Submit 1 Copy To Appropriate District Office District State of New Mexico Office District Agreement Minerals and Natural Resources	Form C-103 Revised July 18, 2013		
District I – (575) 393-6161 Energy Minerals and Natural Resources 1625 N. French Dr., 10 1882 A0 175 JA 3 1814 A 1	WELL API NO.		
811 S. First St., Artesia, NM 88210 MAL Q OIL CONSERVATION DIVISION	30-015-27191 5. Indicate Type of Lease		
1000 Rio Brazos Rd. Aztec. NM 87410	STATE FEE		
District IV – (505) 476-3460 1220 S. St. Francis Dr., Santa Fe, NM 87505 87505	6. State Oil & Gas Lease No.		
SUNDRY NOTICES AND REPORTS ON WELLS	7. Lease Name or Unit Agreement Name		
(DO NOT USE THIS FORM FOR PROPOSALS TO DRILL OR TO DEEPEN OR PLUG BACK TO A DIFFERENT RESERVOIR. USE "APPLICATION FOR PERMIT" (FORM C-101) FOR SUCH	Continental A State		
PROPOSALS.) 1. Type of Well: Oil Well Gas Well Other	8. Well Number

2. Name of Operator EOG M Resources Inc.	9. OGRID Number 15445		
3. Address of Operator	10. Pool name or Wildcat		
105 South Fourth St, Artesia, NM 88210	Turkey Track 7 Rvrs Qn GB SA

LEASE NAME	Continental A State	
WELL#	11	
API#	30-015-27191	
COUNTY	Eddy, NM

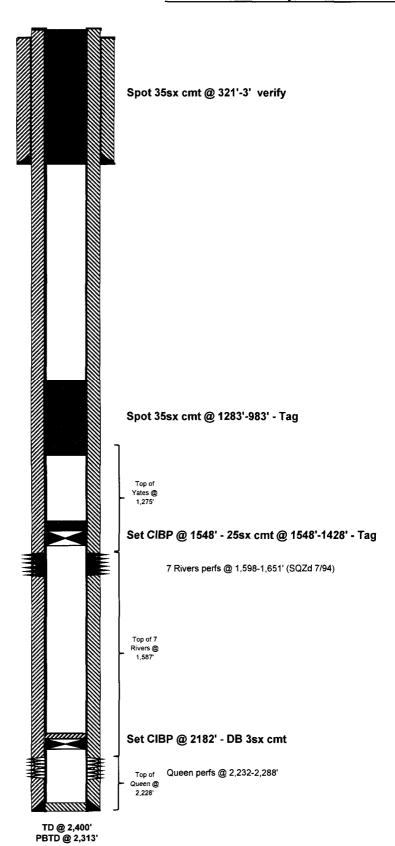
1. MIRU. ND WH, NU BOP 45x 35' 2. Set 5½" CIBP @ 2,182'. Dumpbail 5 sxs @ 2,182' - 2,152'.	-5 9		
2. Set 5½ CIBP @ 2,182 . Dumpoan sxs @ 2,182 - 2,132 . 3. Set 5½ CIBP @ 1,548'. Circ well w/ MLF. Cap BP w/ 25 sxs @ 1,548' - 1,428'.	WOC-Tag

3. Set 5½" CIBP @ 1,548'. Circ well w/ MLF. Cap BP w/ 25 sxs @ 1,548' − 1,428'. WOC-Tag 4. Spot 35 sxs @ 1,283' − 983'. WOC-Tag S S → 1 1050' T 5→ 1 320' CO → #) ∀

5. Spot 35 sxs @ 321'-3'. Part 371' 532			
6. Verify cmt @ surface. Top off if necessary. RDMO. Cut off WH & anchors & inst	all DH marker.		
A closed loop system will be used for all fluids from this wellbore and disposed	d of required by OCD Rule 19.15.17		
Spud Date: Rig Release Date:			
Sput Date.			
Jee Attached CDA's mut be	Physel by 3-5-19		
Thereby certify that the information above is true and complete to the best of my knowledge			
∞			
SIGNATURE TITLE Agent	DATE 2/23/18		
Agent_	DA1L 2/23/10		
Type or print name Greg Bryant E-mail address: For State Use Only	PHONE:		
	2 5 7		
APPROVED BY: TITLE 5/A+ Mg- Conditions of Approval (if any):	DATE 3-5-18		
· · · · · · · · · · · · · · · · · · ·

LEASE NAME	Continental A State	
WELL#	11	
API #	30-015-27191	
COUNTY	Eddy, NM

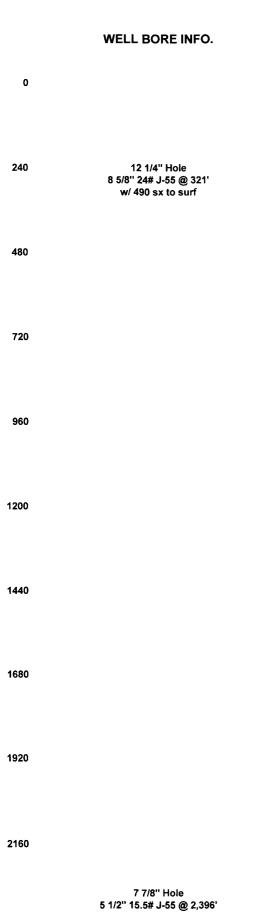
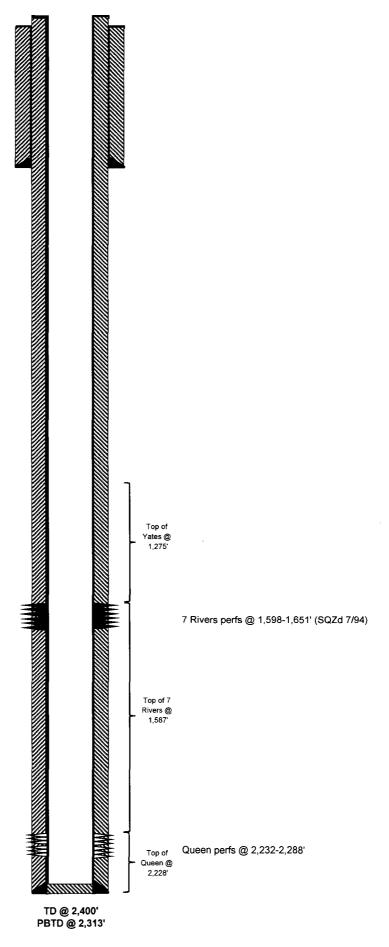
12 1/4" Hole 8 5/8" 24# J-55 @ 321' w/ 490 sx to surf

7 7/8" Hole 5 1/2" 15.5# J-55 @ 2,396' w/ 800 sx to surf
